Amendments to the Drawings:

Attachment: Replacement Sheet

Figure 1

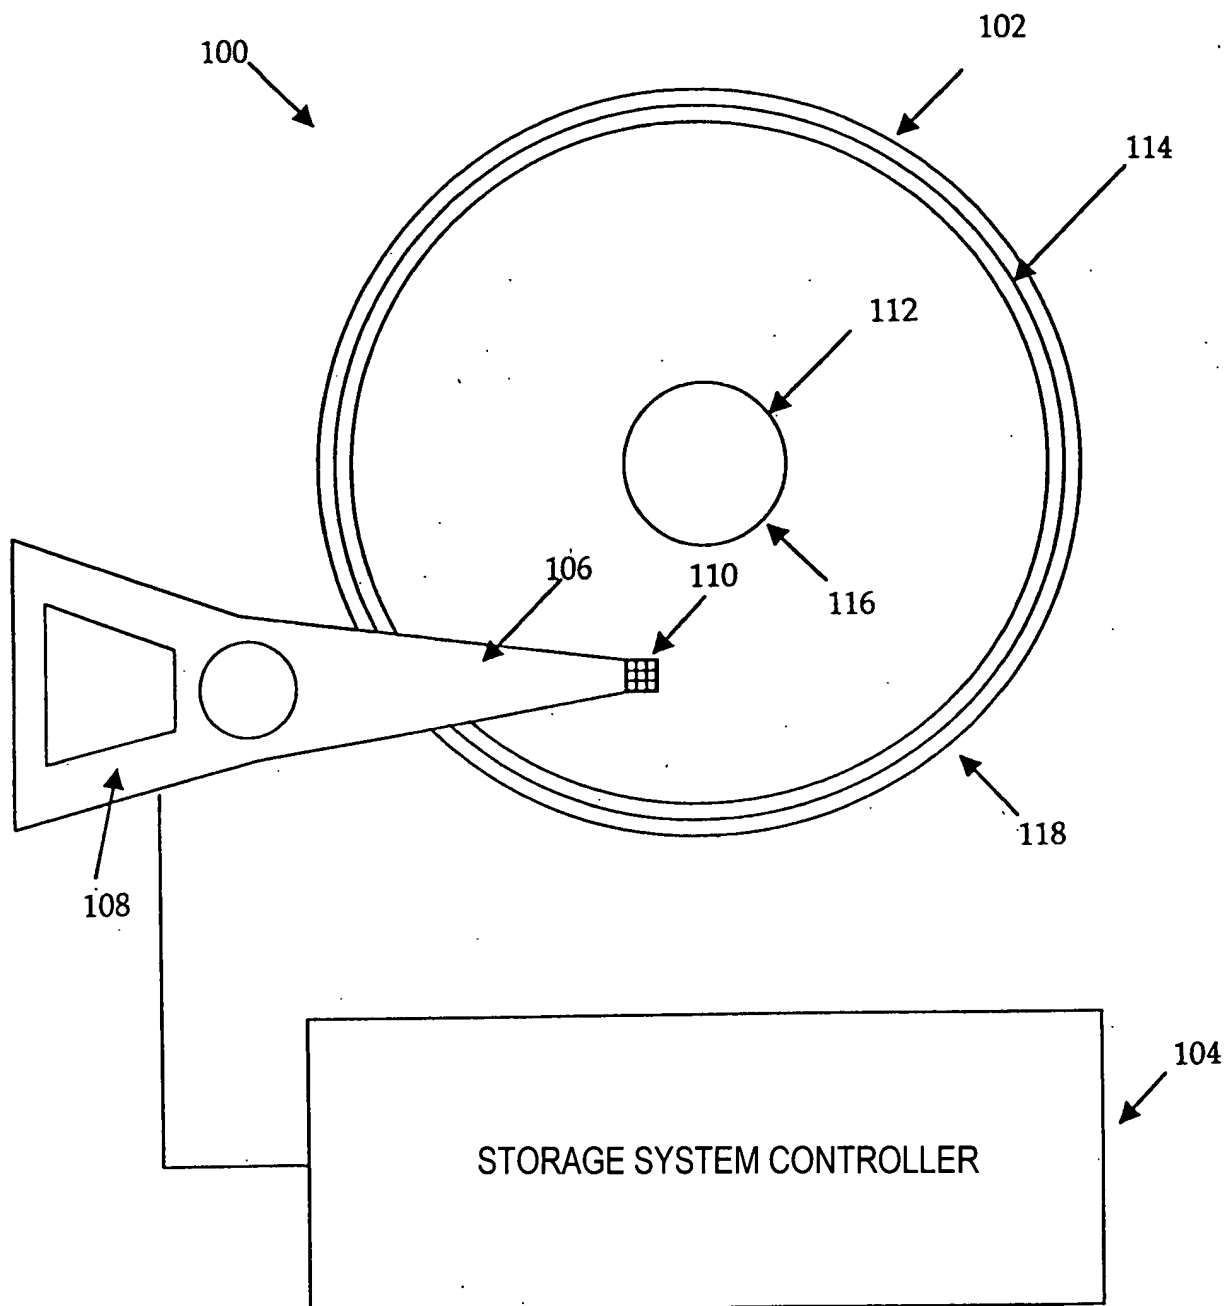
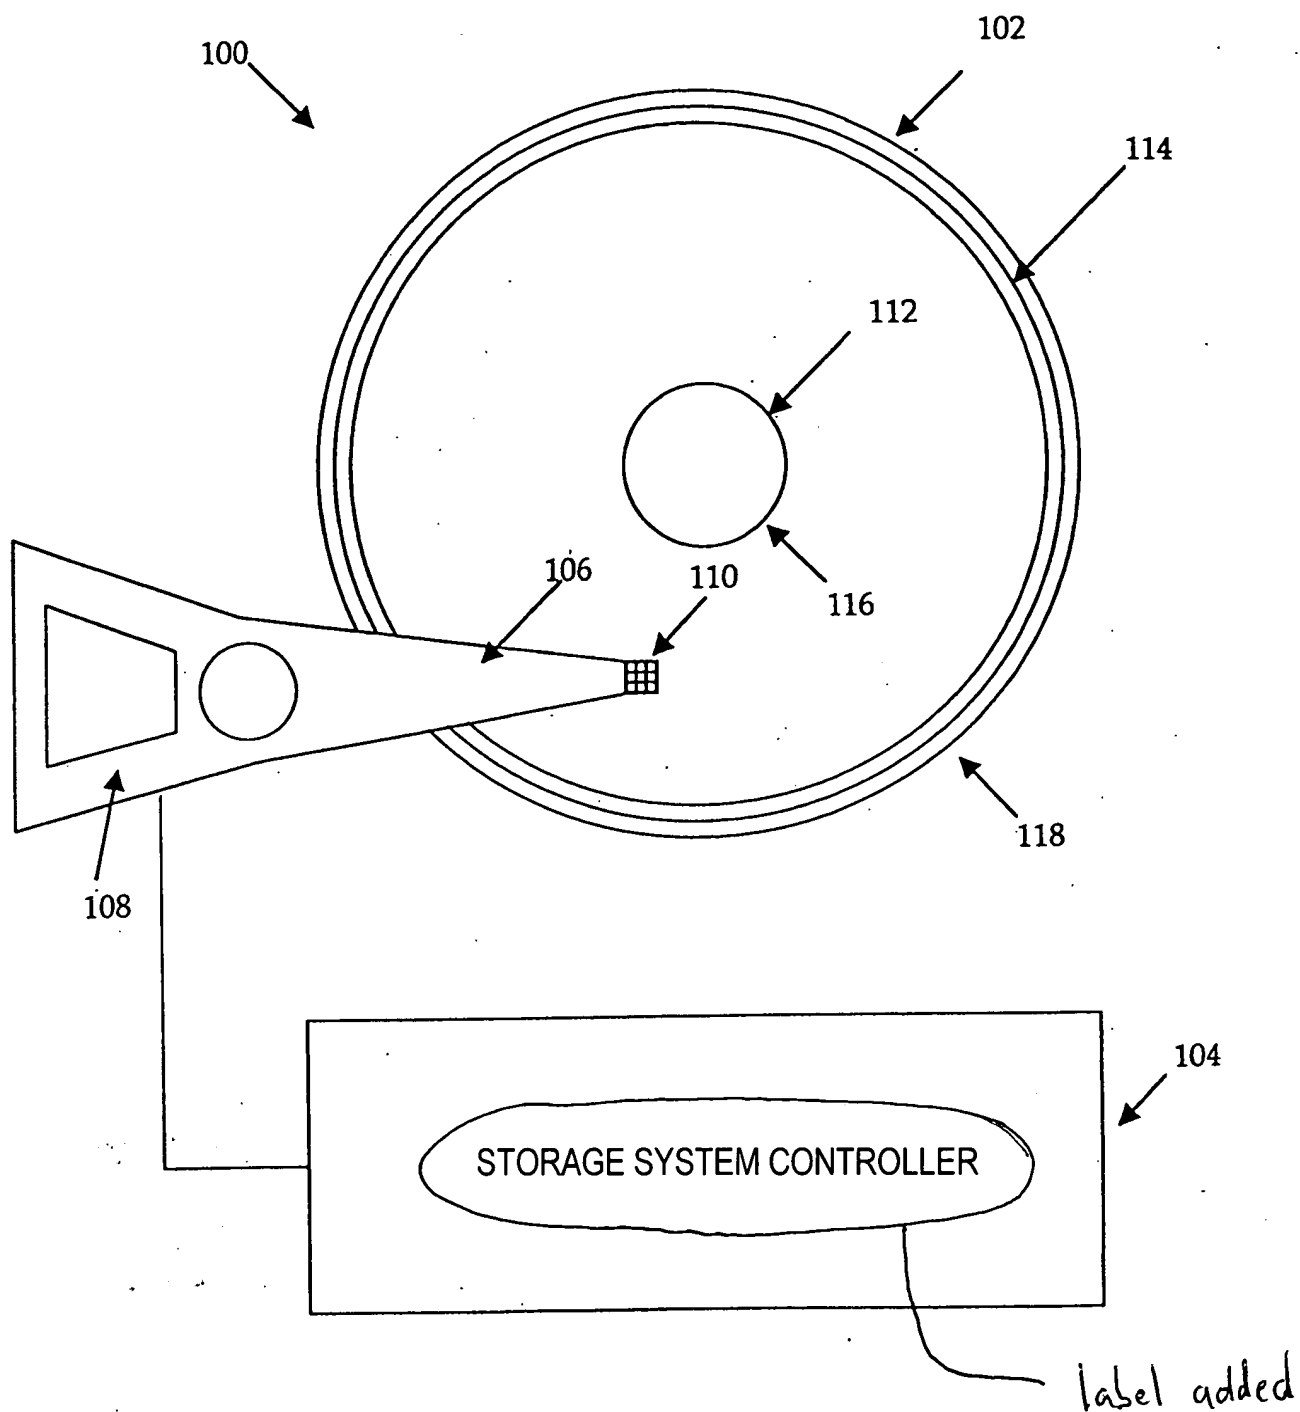
The attached sheets of drawings include changes to Figure 1. These sheet, which include Figure 1 replace the original sheet including Figure 1. In Figure 1, the previously omitted label "storage system controller" has been added.
